Re: Minor Modification to Resource Recovery and Protection Plan (R2P2), Longwall  
Development Around Fire Area, Willow Creek Mine

MINOR MODIFICATION TO  
 MINING PLAN APPROVED BY  
 BUREAU OF LAND MANAGEMENT

**Re: Permit Amendment, Resource Recovery from Schoolhouse Canyon Refuse Pile, Plateau Mining Corporation, Willow Creek Mine, ACT/007/038, Carbon County, Utah**

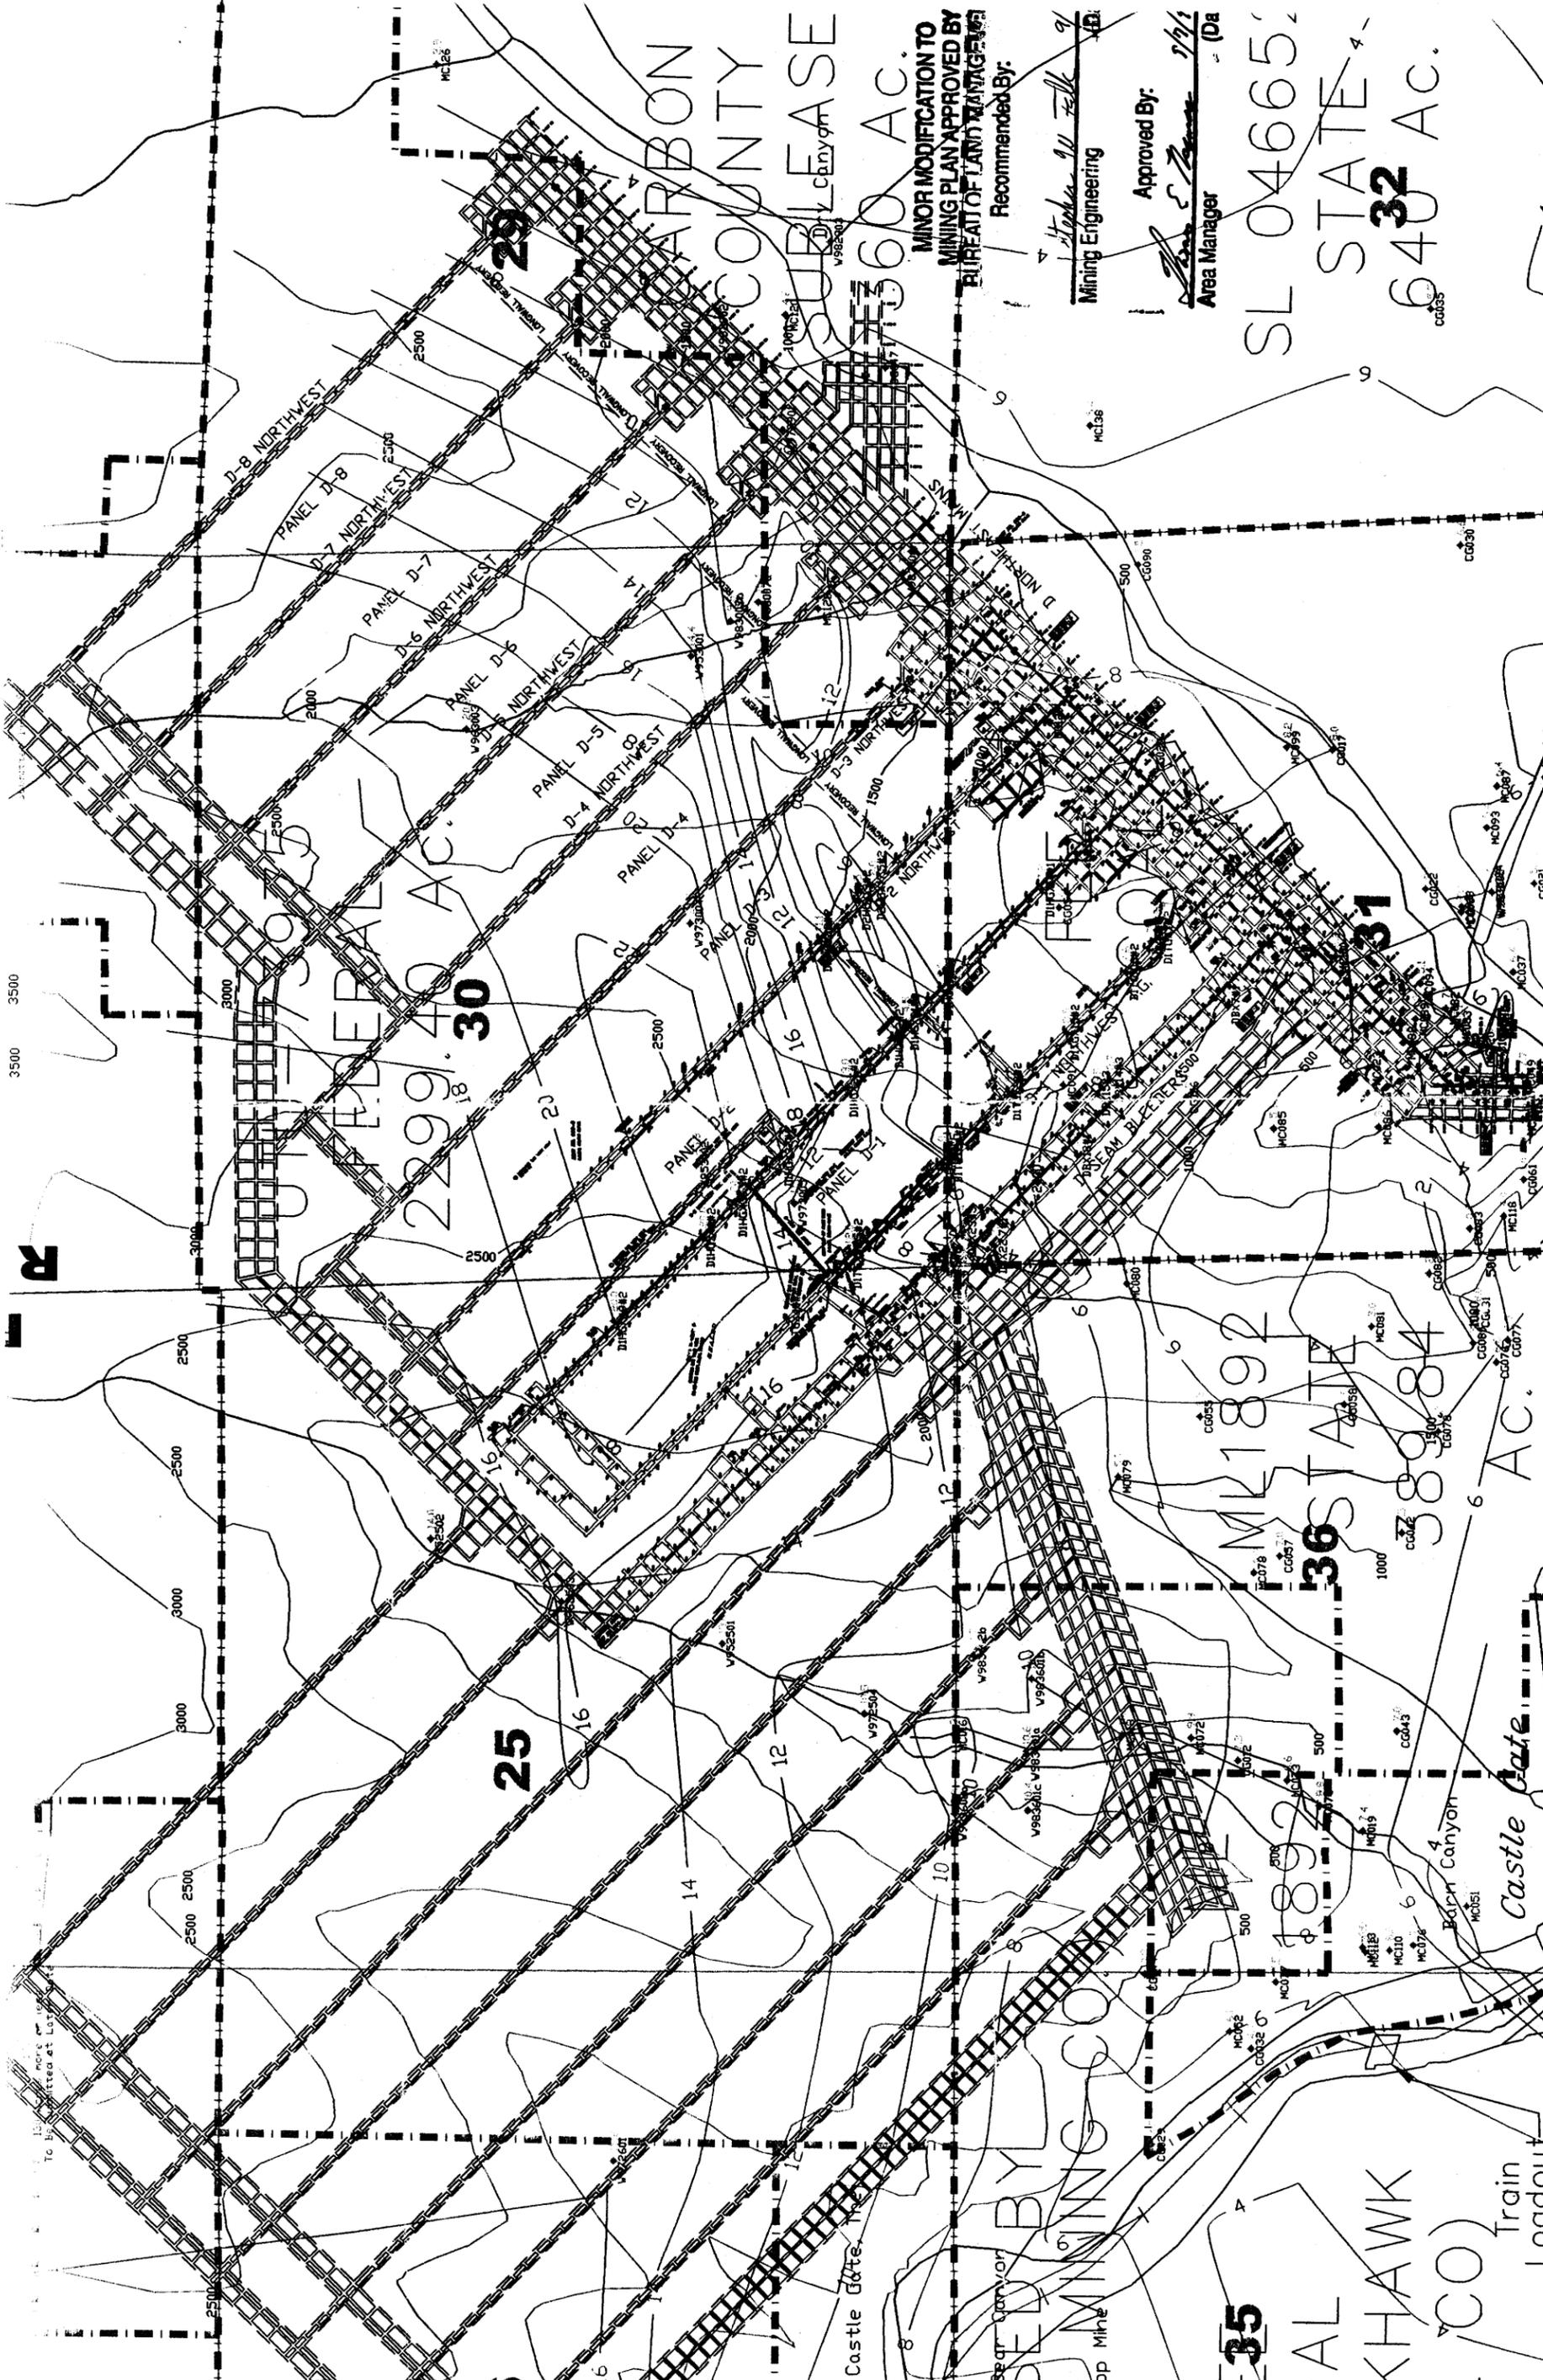
Plateau requests to recover the longwall equipment and isolate the D-1 gob area by sealing off the current longwall face after equipment removal and mining an offset D-2 tailgate entry to form a narrow D-2 panel with a fire barrier to the D-1 gob. In addition, the main D seam bleeder will be extended around the D-1 gob which would allow for the remaining D Northeast panels to be lengthened. D-7 and D-8 panels are planned to be lengthened by adding a 140-acre lease modification to the north boundary of the existing Federal lease UTU-73975. Also, the D Northwest submains will be moved further south which will add some extra length to the northwest longwall panels.

Plateau's need to isolate and recover the longwall machine from the fire area and prepare the mine for future longwall mining is given as justification for the modification. The changes to future D Northeast longwall panels and the location of the D Northwest submains are the result of new geologic information from recent drilling.

Upon our review, the changes requested to return the mine to full production after the mine fire are justified. The current D-1 longwall face, where the fire occurred, cannot be further mined as the chances are too great that the gob could reignite should ventilation be re-established. The remaining D-1 panel cannot be mined because the remaining coal block to the channel scour/seam split would be too short, as a fire barrier would be required to the old longwall face. Also, the tailgate entries were fire damaged beyond practical repair for much of the length of the remaining panel. We also concur with the new D-2 tailgate offset as this would allow for

extraction of the full length but narrowed D-2 panel and still isolate the D-1 gob. The remainder of the changes involve extension of the D-1 through D-8 longwall block with the associated bleeders and with the new D Northwest submains which will allow extra length to the northwest longwall panels. The resulting conditions from the mine fire that made these modifications necessary have been well documented and verified.

The BLM has determined that the proposed modification complies with the Mineral Leasing Act of 1920, as amended, the regulations at 43 CFR 3480, the lease terms and conditions, and will achieve maximum economic recovery of the Federal coal. Plateau's revised R2P2, as depicted on the enclosed map, is approved as submitted, subject to any requirements of the Mine Health and Safety Administration. The mining layouts in the two north lease modification areas are approved, contingent upon the issuance of the lease modifications. Also, a general modification is granted to place the D Northwest submains at the limits of acceptable coal height. This approval confirms verbal approval given to resume mining in the bleeders, the D-2 headgate, and the offset D-2 tailgate.
